National TAB  
1329 E. KEMPER ROAD  
SUITE 4210  
CINCINNATI, OH 45246

**Report: TAB Addendum**  
**Function: Test, Adjust, & Balance**  
**Date: 03/10/2026**  
**Completed By: National TAB**

**PROJECT**  
**03-02-26 CULVERS - MESA, AZ**

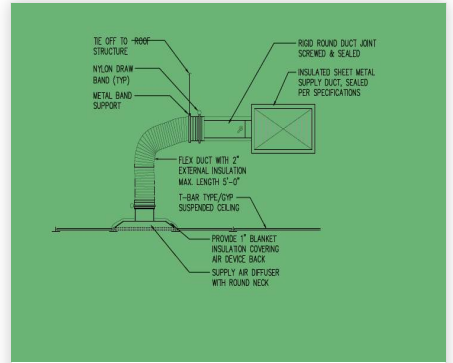
**Issue Name :** RIGID DUCT NOT INSTALLED  
**Description :** MSET details cookline duct flex to come from a rigid straight pipe. Duct is flex only on some branches and is not straight. Recommend installing straight pipe from main supply drop and duct coming down straight, not curvy, so no smoke issues arise in kitchen and flow balances properly. UPDATE: FIXED, SHOWN IN 2ND PIC
